NFPA 805 OBSERVATION VISIT TRIP REPORT

Date: April 14-16, 2008

Subject: Observation Visit for Pilot Plants Transitioning to National Fire Protection Association (NFPA) Standard 805, "Performance-Based Standard for Fire Protection for Light Water Reactor Electric Generating Plants."

Figure 1. Multiple Spurious Post-Transition Inspections

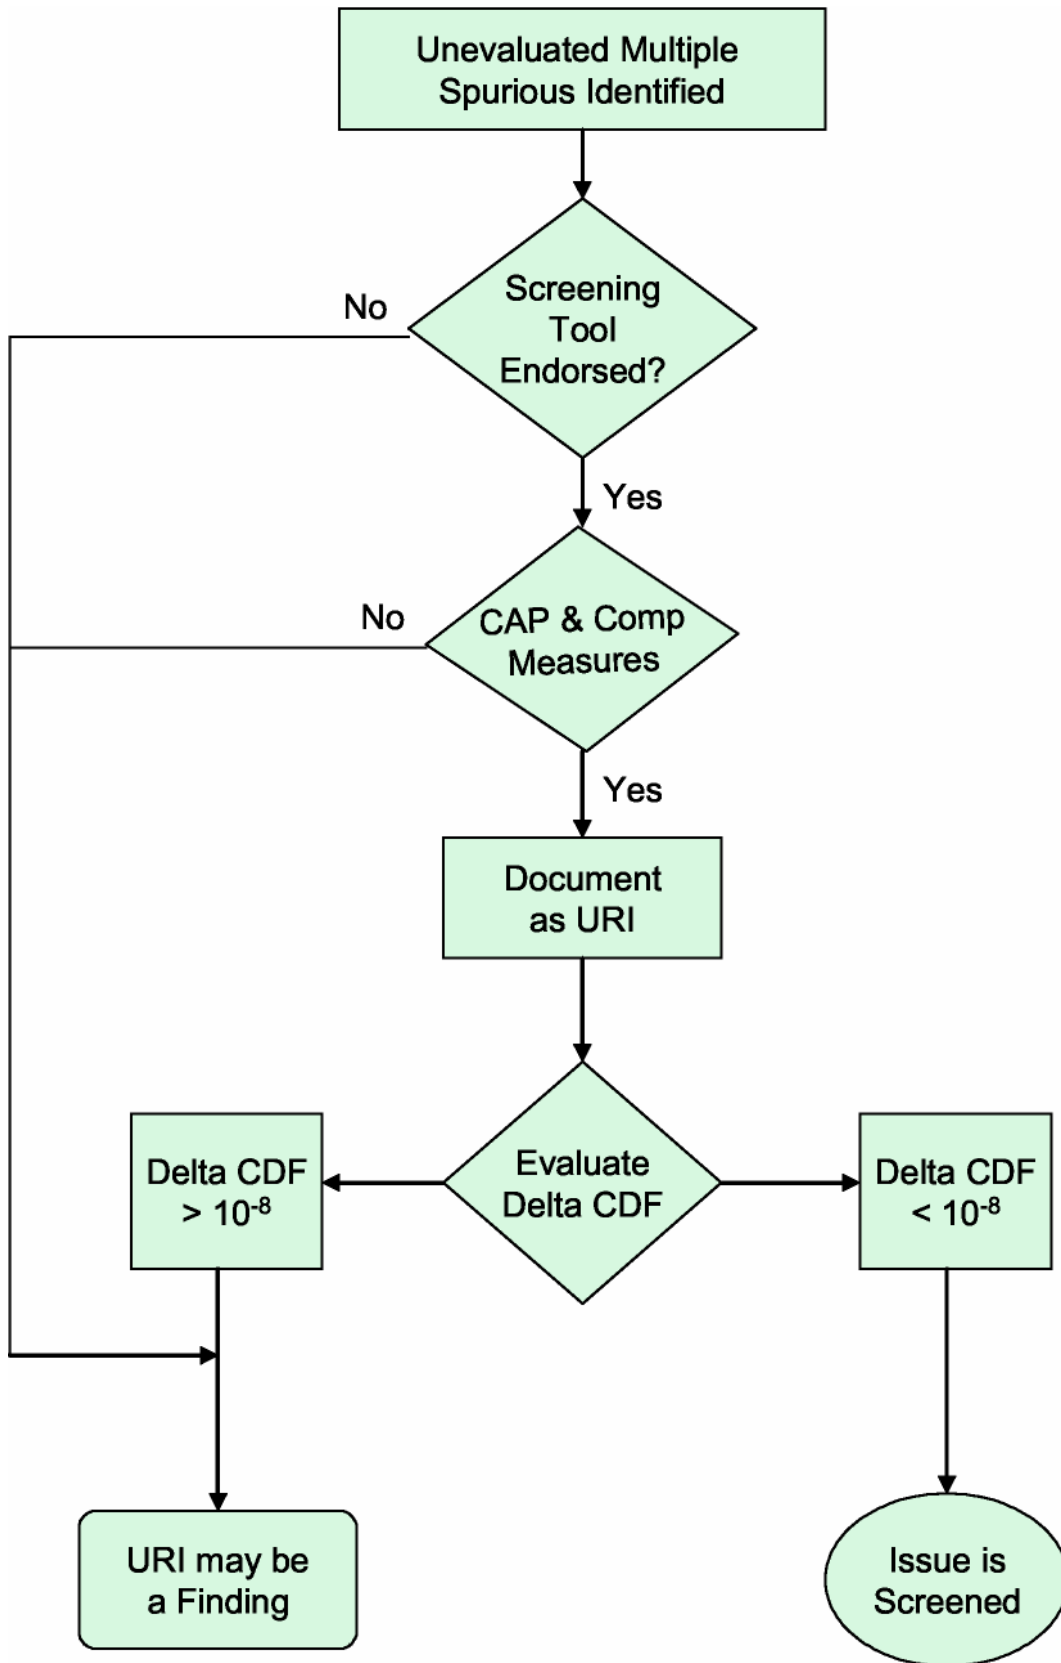
At the March 2006 pilot plant observation visit, the Staff presented a flow chart, illustrating how newly found multiple spurious circuits identified during an inspections, could be treated (See flow chart below). In addition to the flowchart, the following information was discussed:

Resolution Action(s)/Action Party: OPEN. Industry and pilot-plant participants agreed to review the flowchart, IMC 0612 questions, screening thresholds and provide feedback to the NRC at the next observation meeting. The industry may also submit an FAQ on the issue.
